Service Bulletin

Bulletin No.: 21-NA-246

Subject: Unwanted Front Windshield Wiper Swipe, Cruise Control Will Not Turn On, Steering Wheel Controls Inoperative, DTCs P155A/00, B1529/03

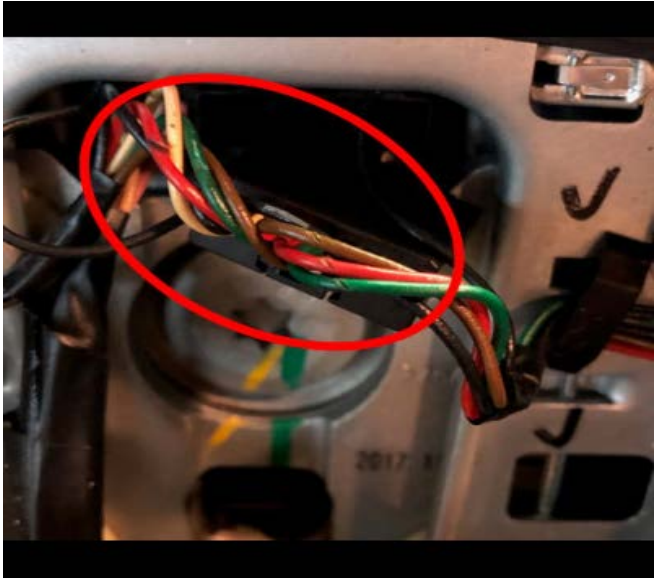
<p>Cause</p>	 <p style="text-align: right;">5480325</p>  <p style="text-align: right;">5480327</p> <p>The cause of the condition may be the steering wheel harness shorted under the steering wheel inflator module.</p>
<p>Correction</p>	<p>If you encounter a vehicle with the above concern, inspect and repair the steering wheel harness referring to the proper wire repair procedures. Refer to <i>Wire to Wire Repair</i> in SI.</p>
